<b>Office Action Summary</b>	<b>Application No.</b>	<b>Applicant(s)</b>	
	10/813,701	SIMARD, GILLES	
	<b>Examiner</b>	<b>Art Unit</b>	
	Amy J. Sterling	3632

This is the first Office Action for application number 10/813,701 Attachment bracket for Shelf Support System, filed on 2/6/03. Claims 1-21 are pending. This application claims priority to now abandoned 09/776,321, filed 2/2/01.

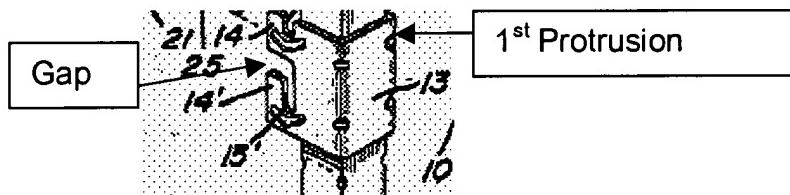
Trubiano discloses applicant's basic inventive concept including an attachment bracket having a back wall (13) defining a bottom, a top and vertical edges, and side arms (14) extending laterally from the vertical edges of the back wall, at least a first protrusion (See Drawing Below) located on the inner surfaces of the bracket each of the side arms having an upper and lower slot (15, 15'), the upper slots being open on each arm. Trubiano also discloses wherein each of the side arms has a gap (See Drawing) open at a lateral edge thereof.
